PROPOSED UPLAND LANDFILL

HYDROGEOLOGICAL REVIEW

BY: DR. GILLES WENDLING, P.ENG.
GW SOLUTIONS

FOR:
CAMPBELL RIVER ENVIRONMENTAL
COMMITTEE (CREC)

CROSS-SECTION A-A'

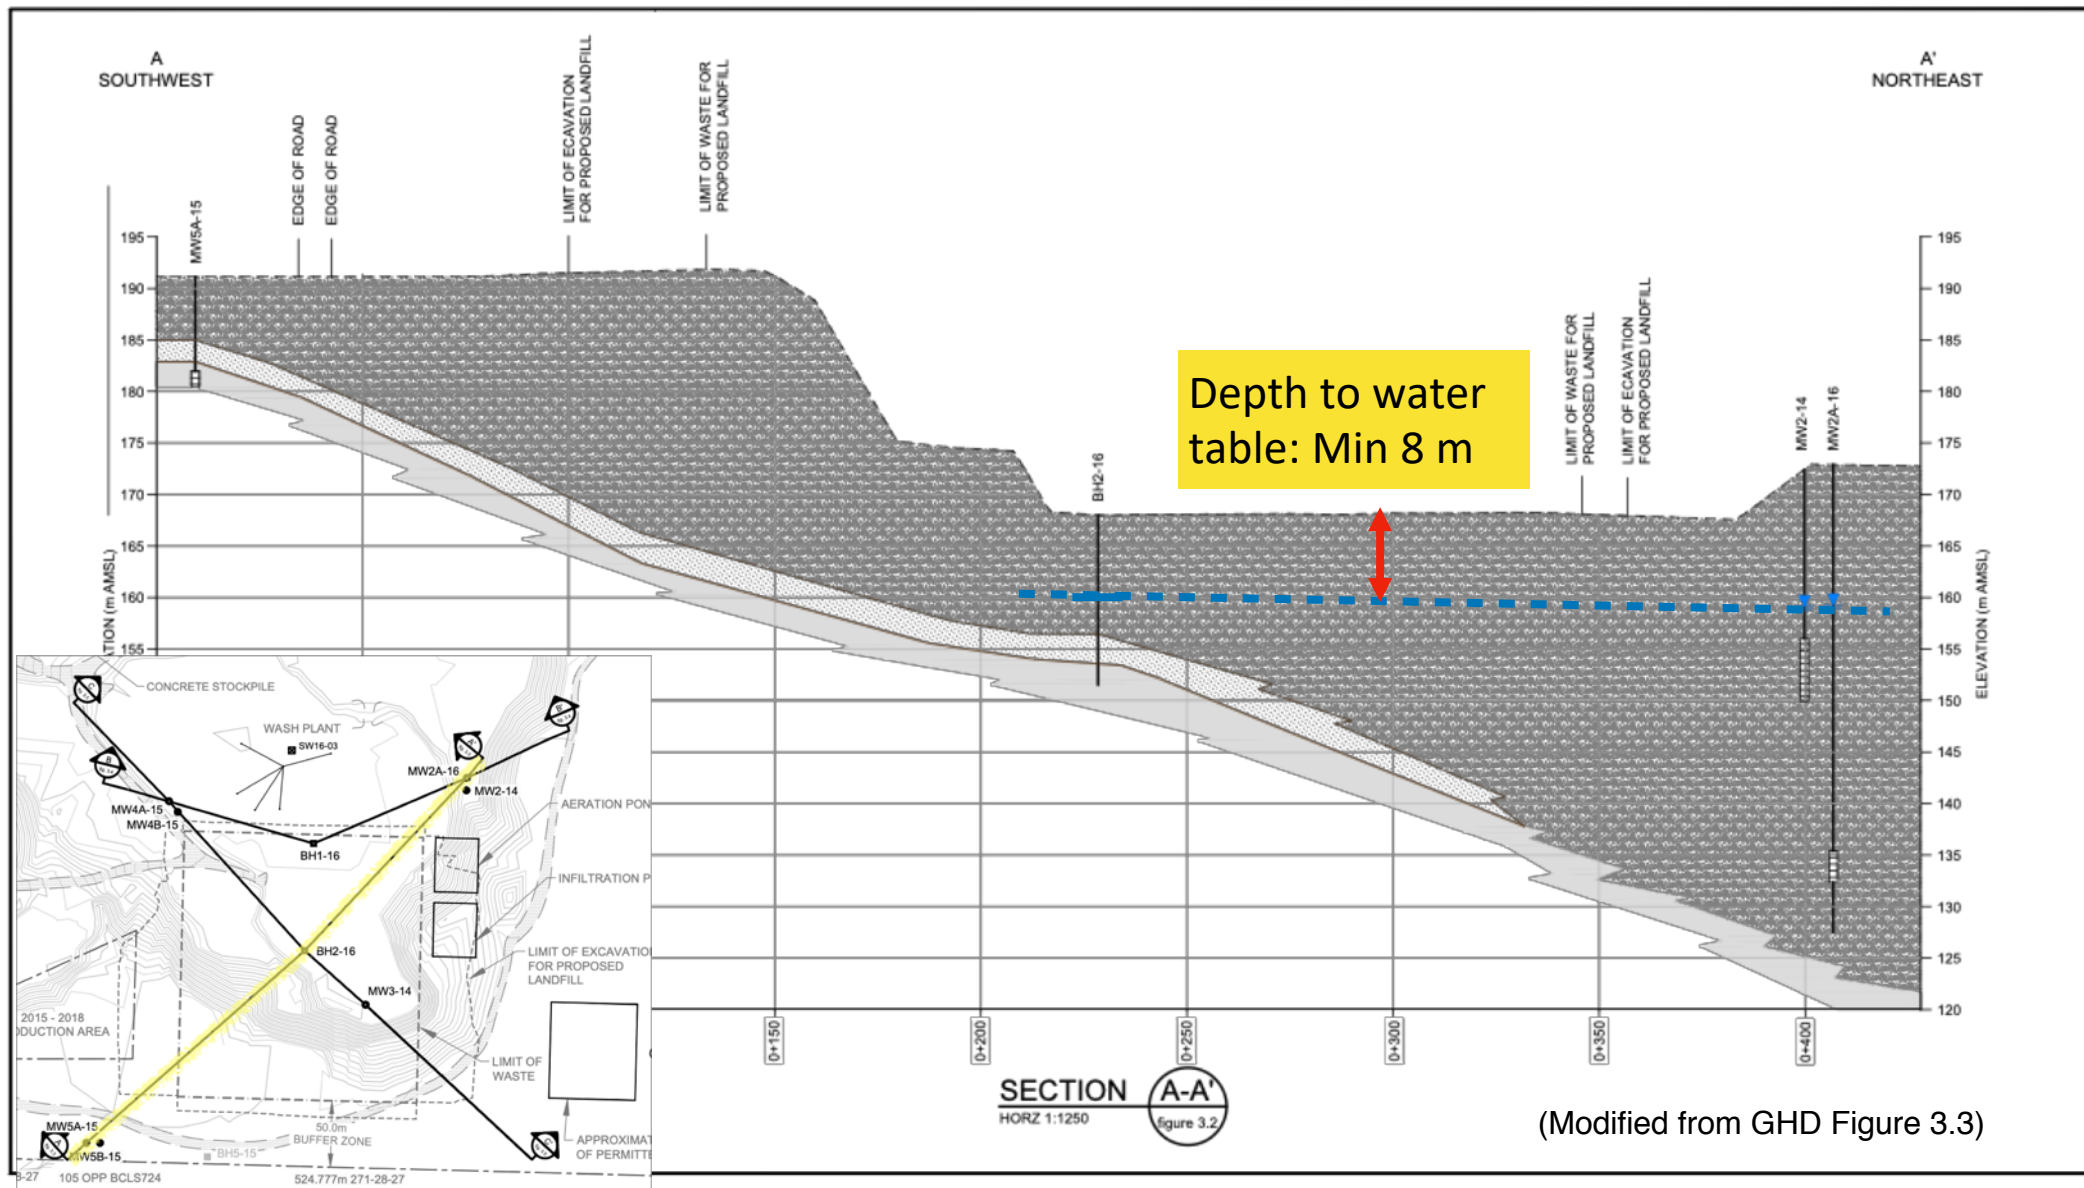
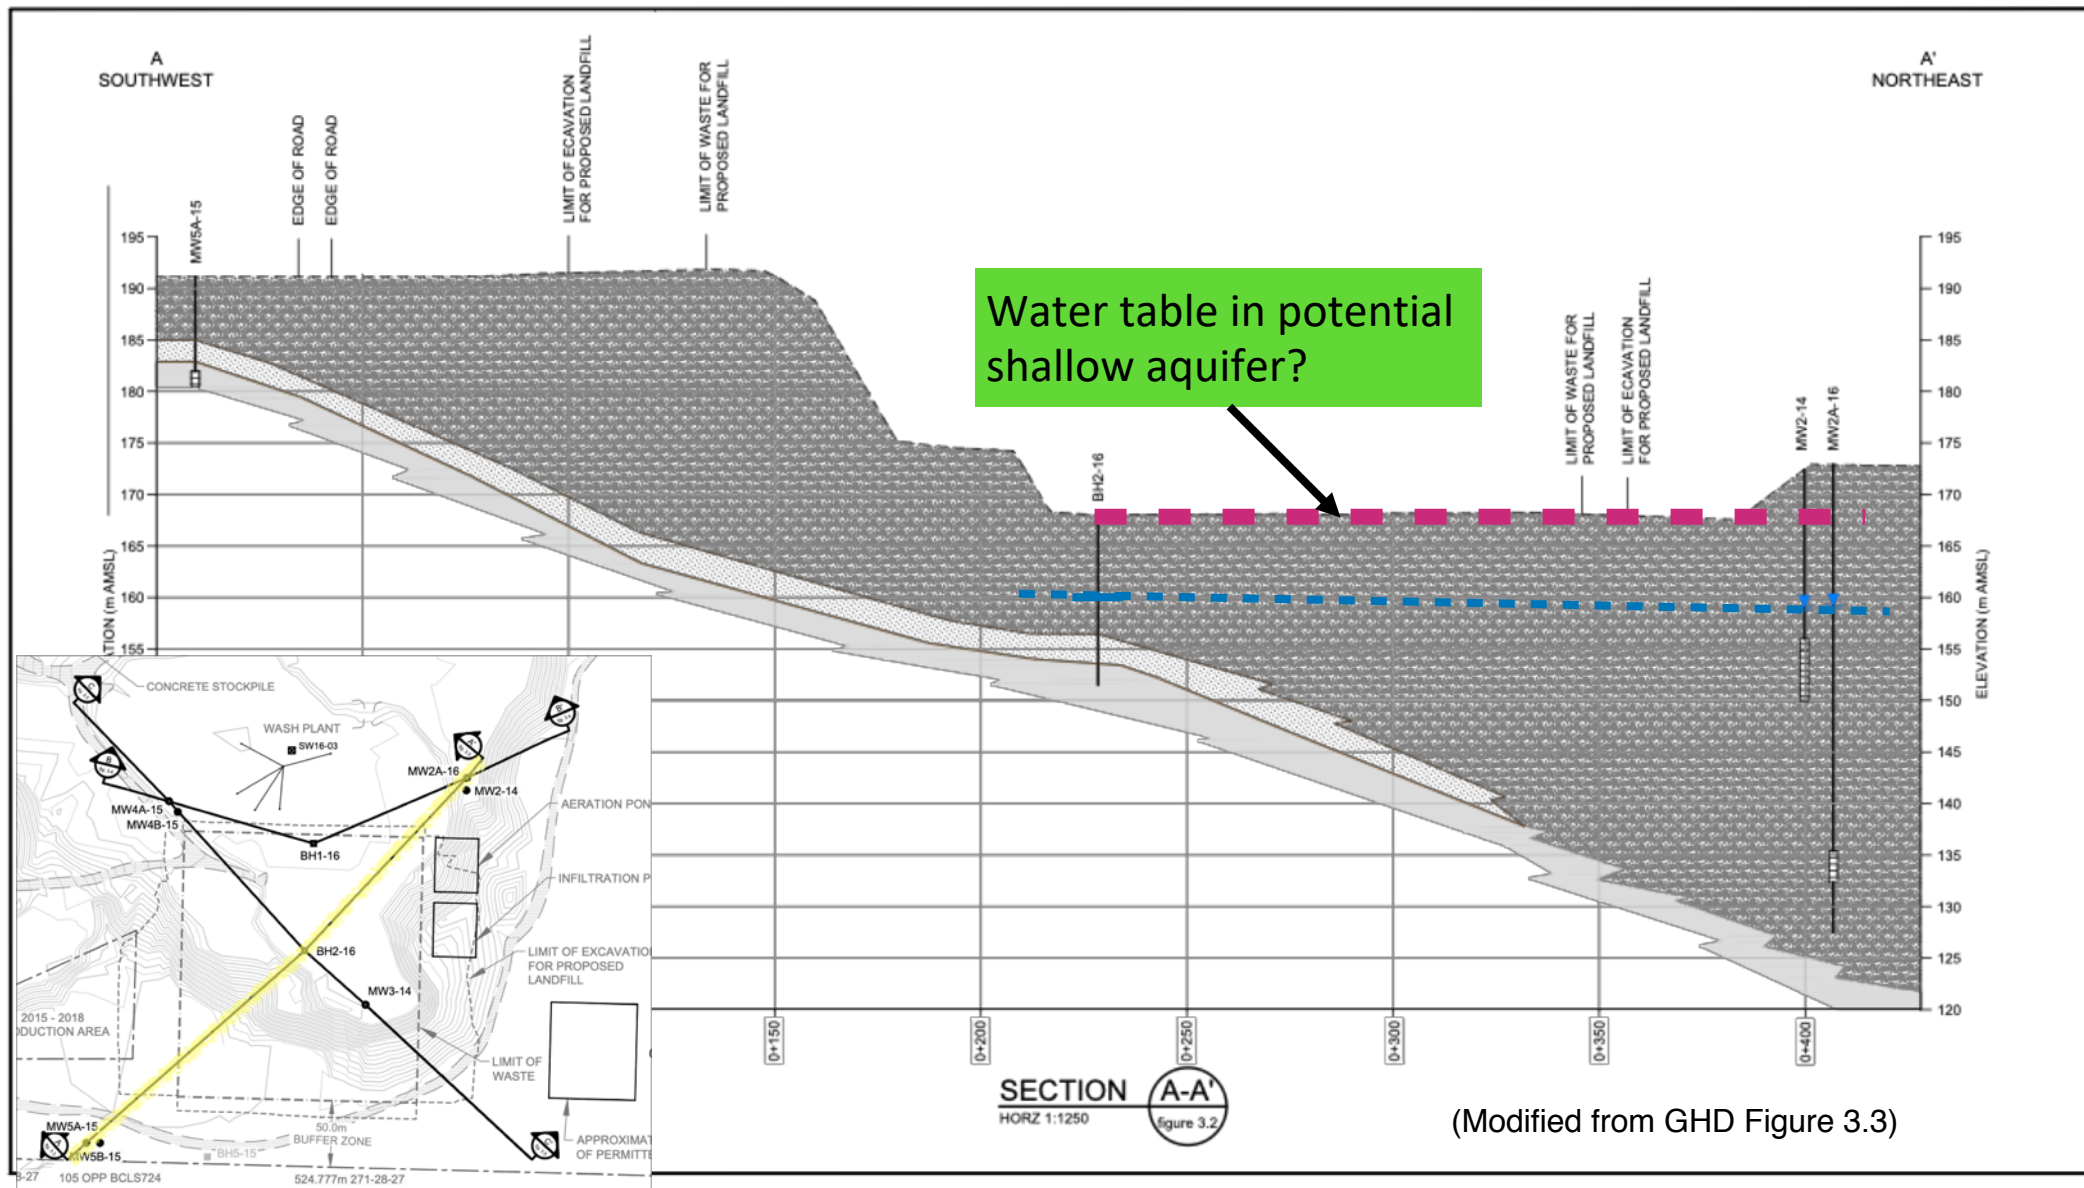
- Groundwater Flow in Bedrock
- Risk of Impact to Rico Lake - Part of Drinking Water Source
- **High Water Table in Existing Pit**

Picture taken on December 11, 2018
